**BEFORE THE PUBLIC SERVICE COMMISSION  
OF THE STATE OF NORTH DAKOTA**

Denbury Green Pipeline – North Dakota, LLC  
12-inch Cedar Hills Pipeline Project  
Slope and Bowman Counties  
Siting Application

Case No. PU-19-294

**APPLICATION FOR AMENDMENT OF  
CERTIFICATE OF CORRIDOR COMPATIBILITY**

**Figure 2. Map with paleontological resource analysis area for Reroute 2.**

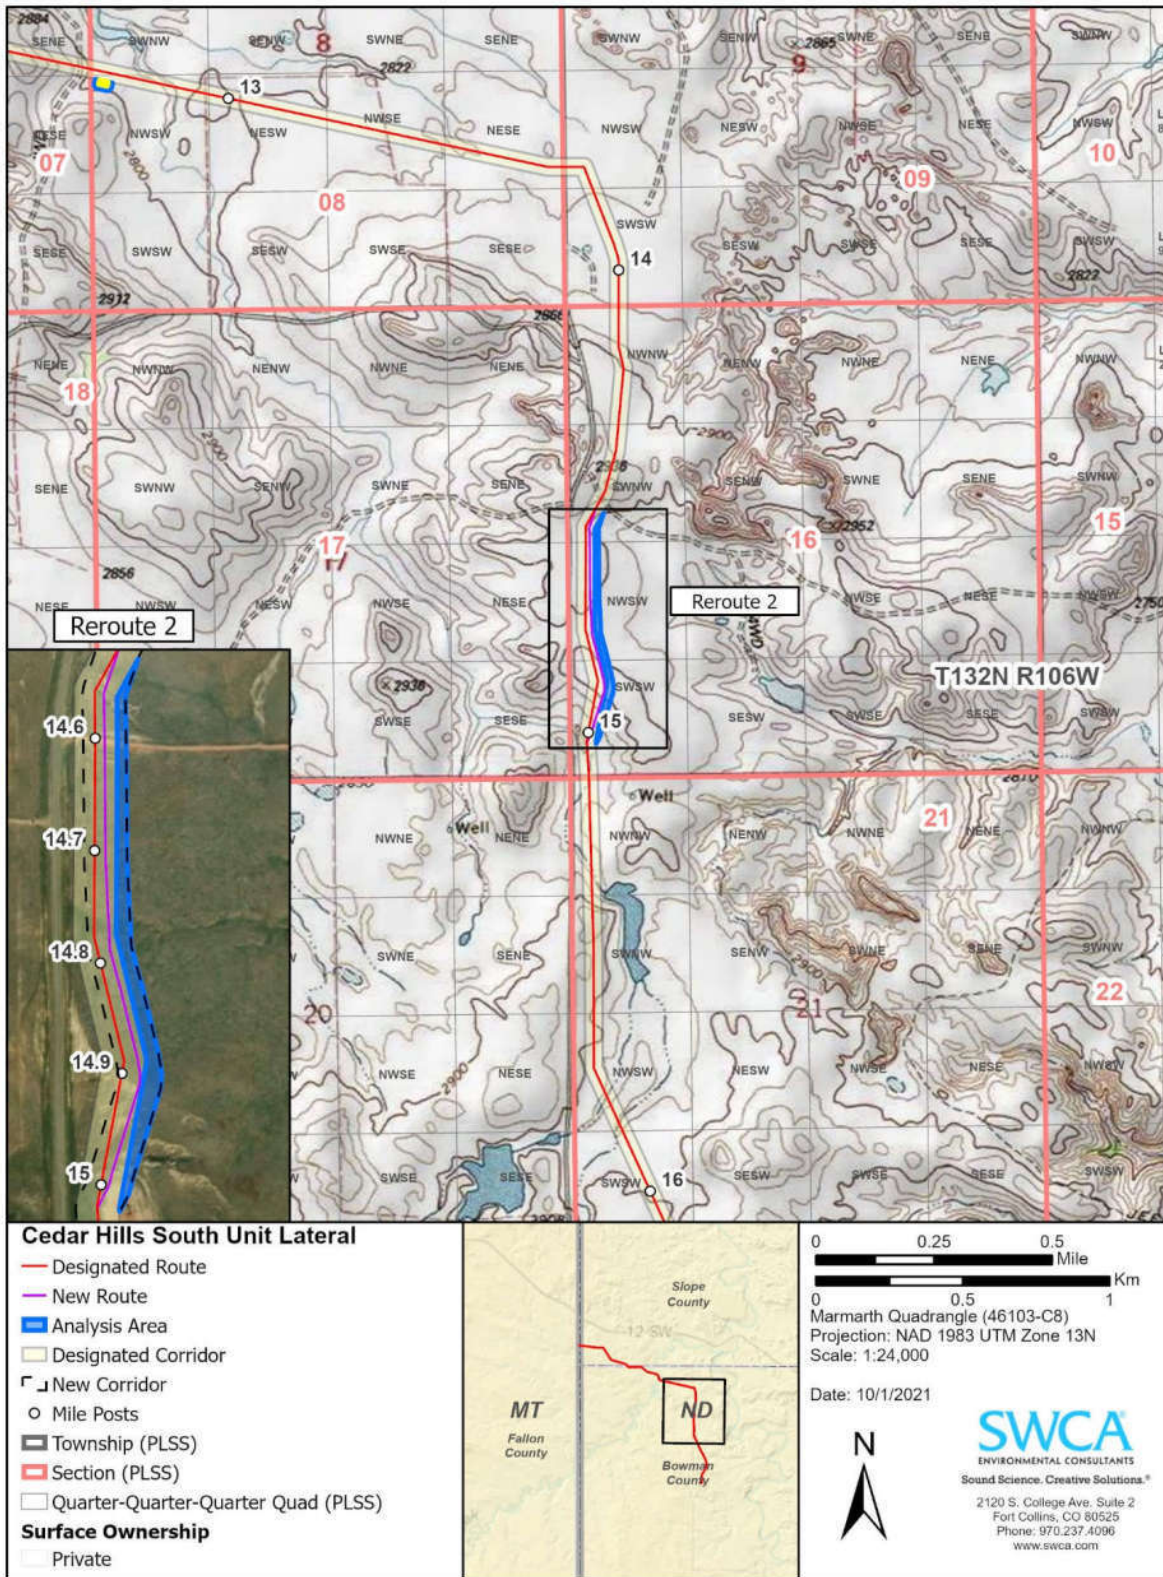
- Reroute 2 (# CHSU-CL-004), from milepost MP 14.5 through MP 15, is adjacent to a portion of the project analysis area that was previously surveyed for paleontological resources. No paleontological resources were observed during initial paleontological project surveys near this reroute (Knauss et al., 2019) and no pedestrian survey was conducted for this reroute. The route adjustment is to the east within the Fischer property and the length of the segment is 0.5 miles. While there is a sandstone exposure, possibly of the mapped Hell Creek Formation within the analysis area at MP 14.9, the route shift (e.g., no more than 30 feet east) keeps most of the proposed disturbance area within the previously surveyed area and/or mostly vegetated areas. In addition, as is typical with standard paleontological survey methodology, pedestrian surveys of small exposures of this type would be unlikely to detect any significant paleontological resource. Exposed paleontological resources are not expected within the route adjustment.

**Figure 3. Map with paleontological resource analysis areas for ATW 5.**

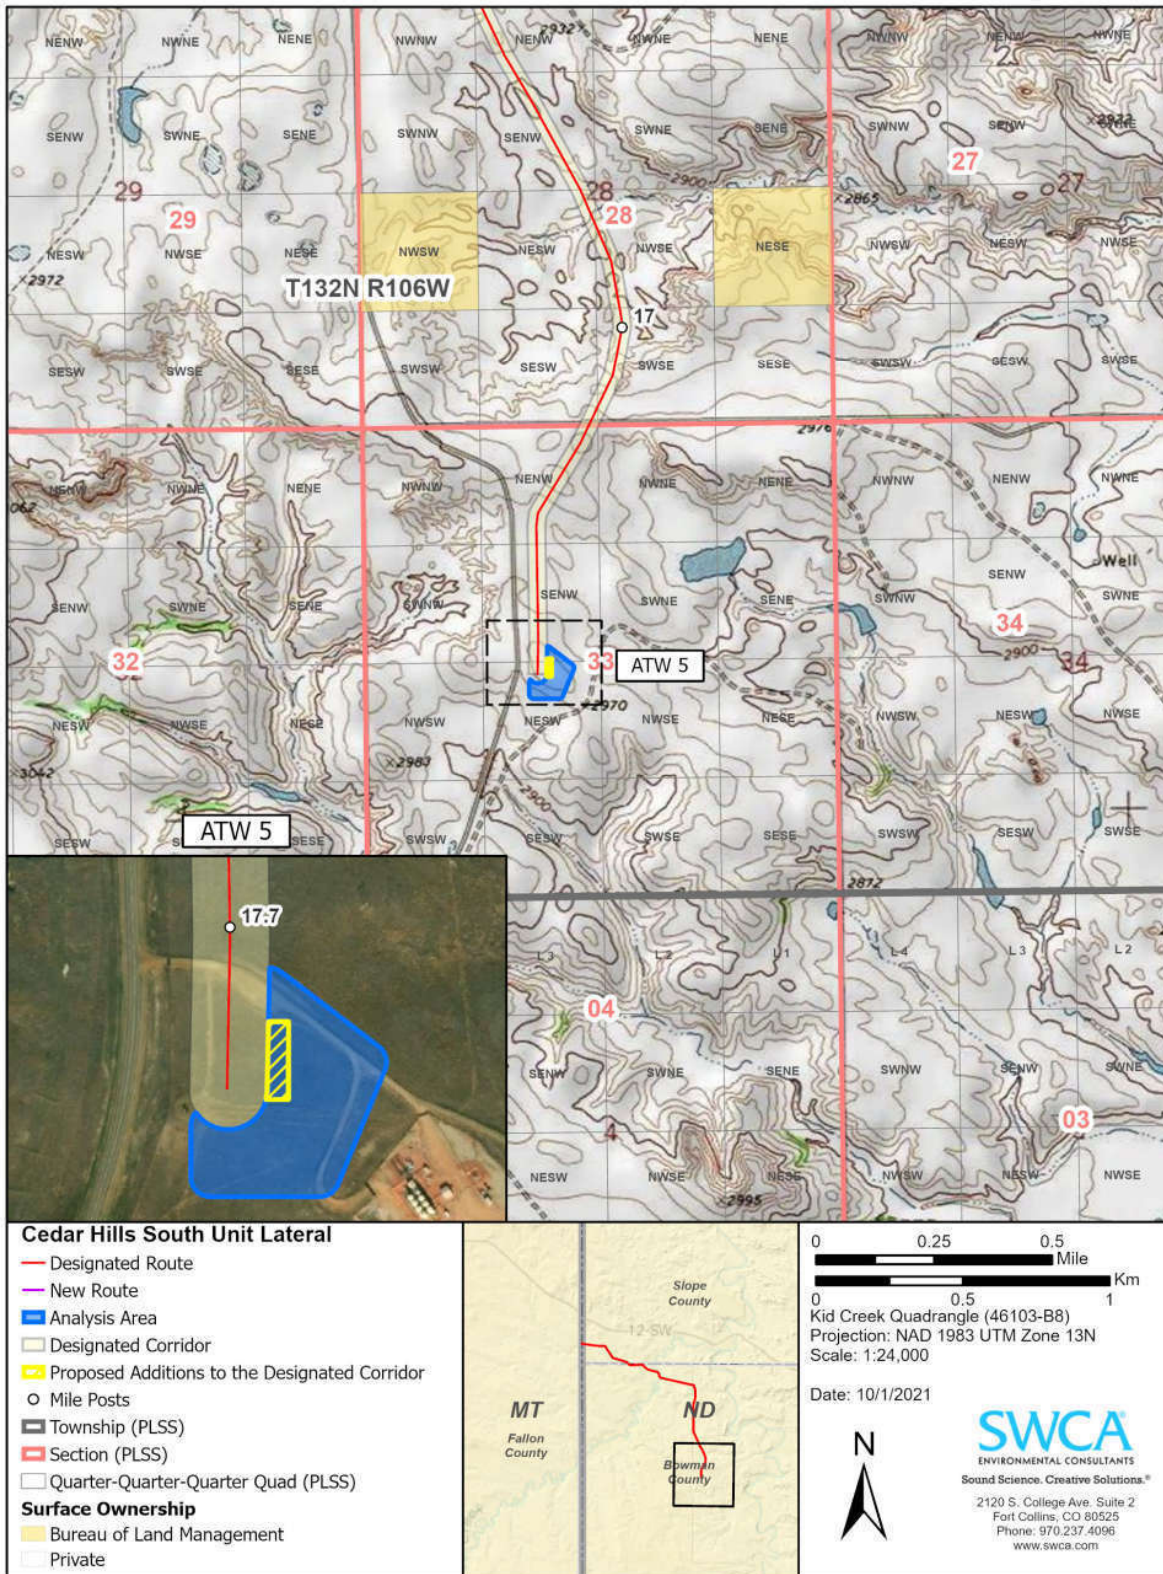
- ATW 5, south of MP 17.7, is in a portion of the project that was previously cleared through an aerial image review and a visual review conducted during pedestrian paleontological surveys in the area due to lack of bedrock exposures. The area is vegetated with no exposures of the mapped Hell Creek Formation. Exposed paleontological resources are not expected within the ATW.

**Exhibit "A"**  
**CH.ND.BO.0011.000**

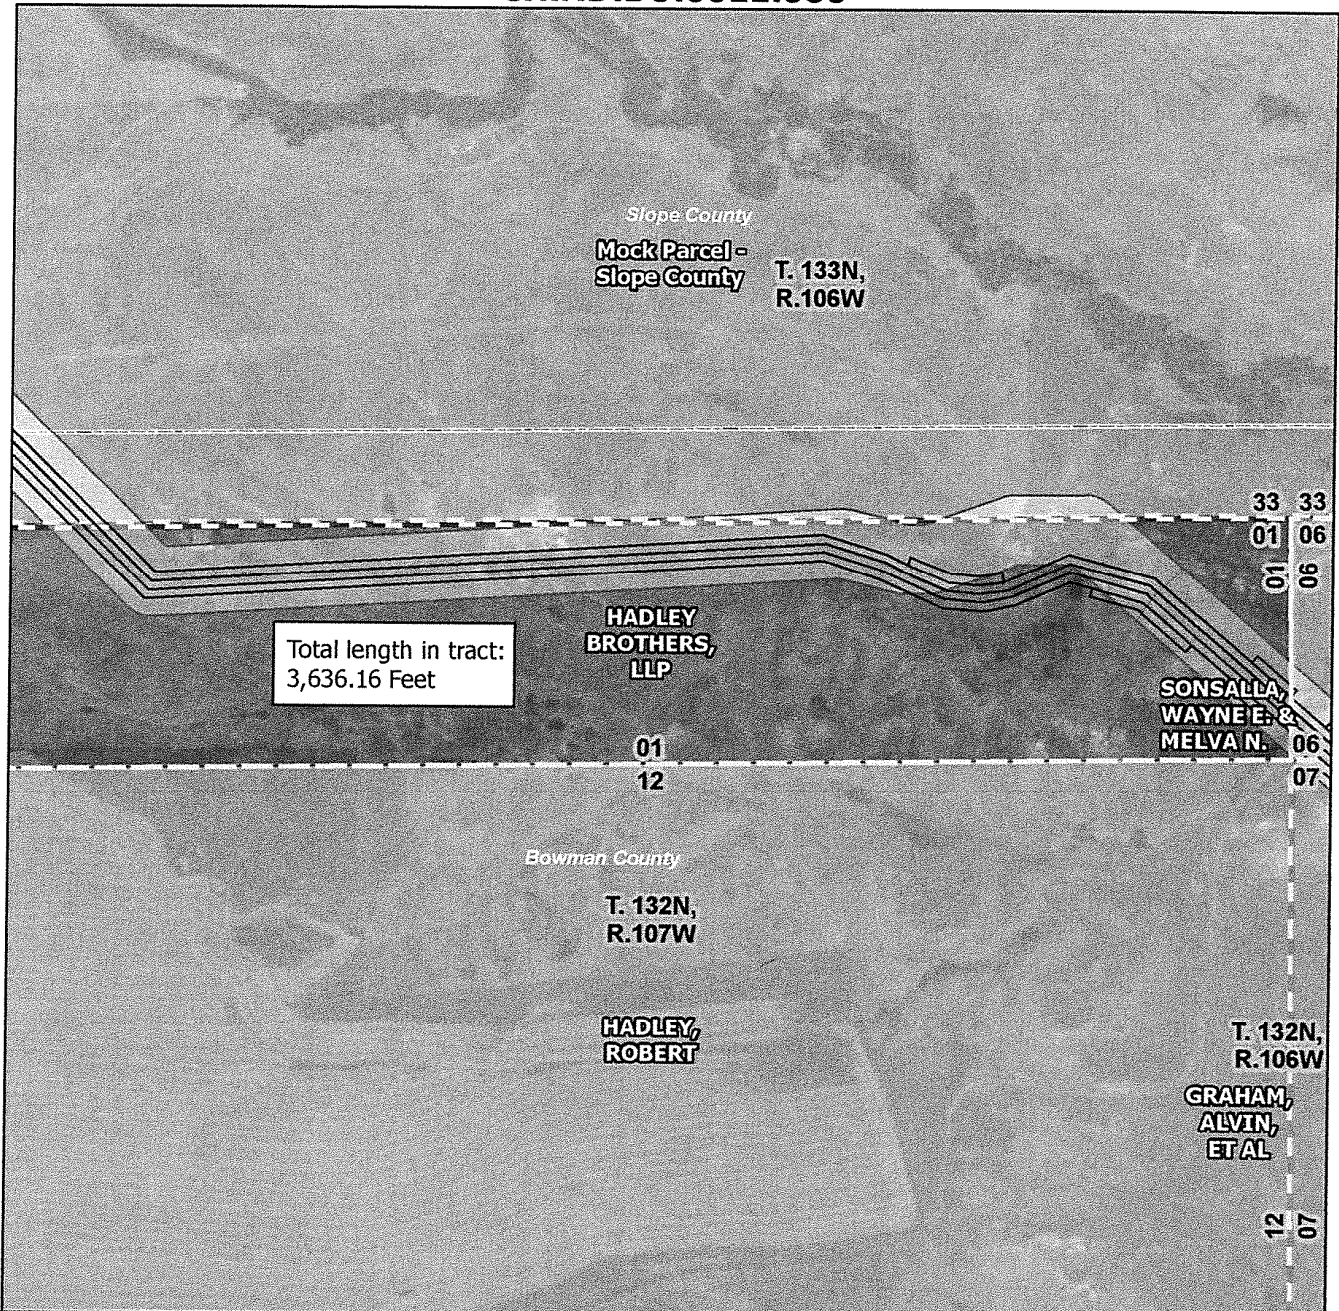
WHEREAS, due to engineering and construction factors, Grantee needs to move a portion of the pipeline route that crosses Grantor’s land by more than fifty (50) feet from the pipeline route described in the Agreement and depicted on the Exhibit “A” attached thereto; and

- 1. The Easement Area, the corresponding temporary work spaces, and the Exhibit “A” of the Agreement are hereby amended to reflect and include the new portions of the pipeline route, which are more specifically described and depicted on the attached Exhibit “A” to this Amendment. The unchanged portions of the Easement Area and the temporary work spaces described in the Agreement shall remain in full force and effect.

**Cedar Hills South Unit Lateral Project**  
**Proposed Project Change:**  
**Fischer Property Reroute**  
 Page 1 of 1

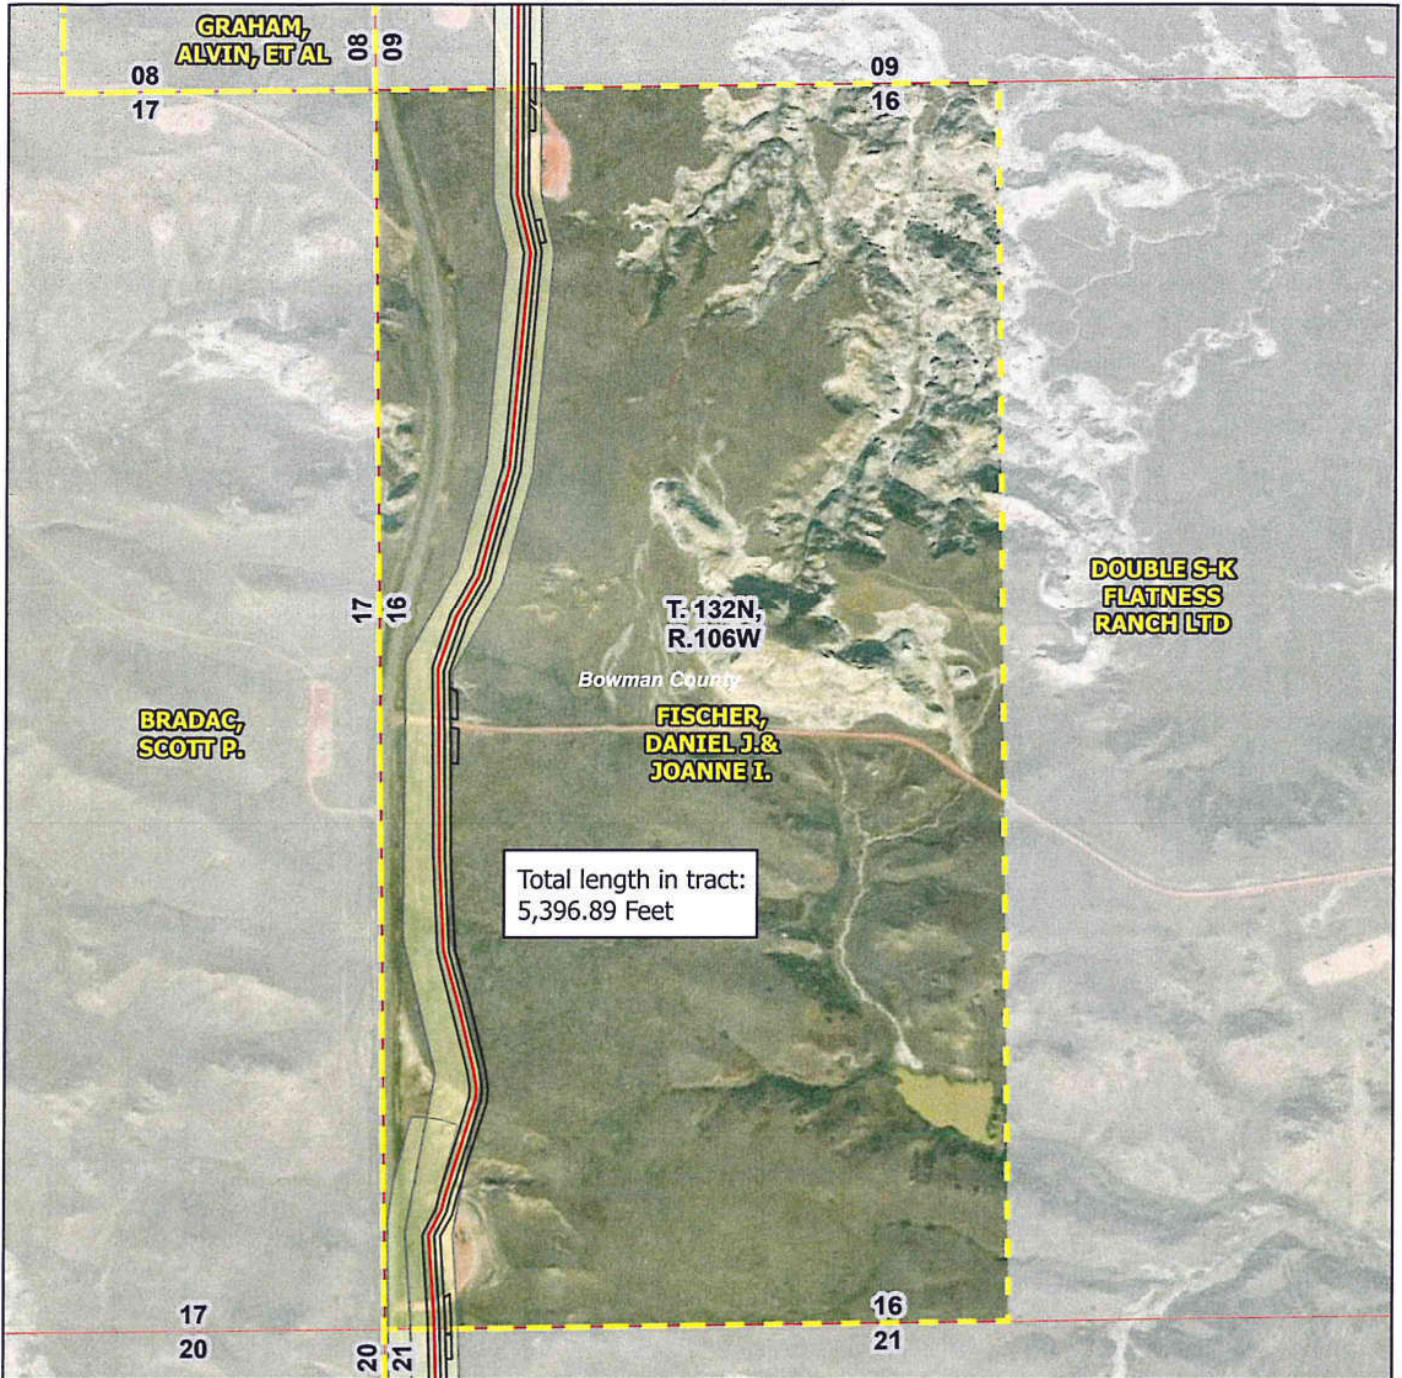
WHEREAS, due to engineering and construction factors, Grantee needs to move a portion of the pipeline route that crosses Grantor’s land by more than fifty (50) feet from the pipeline route described in the Agreement and depicted on the Exhibit “A” attached thereto; and

1. The Easement Area, the corresponding temporary work spaces, and the Exhibit “A” of the Agreement are hereby amended to reflect and include the new portions of the pipeline route, which are

more specifically described and depicted on the attached Exhibit "A" to this Second Amendment. The unchanged portions of the Easement Area and the temporary work spaces described in the Agreement shall remain in full force and effect.
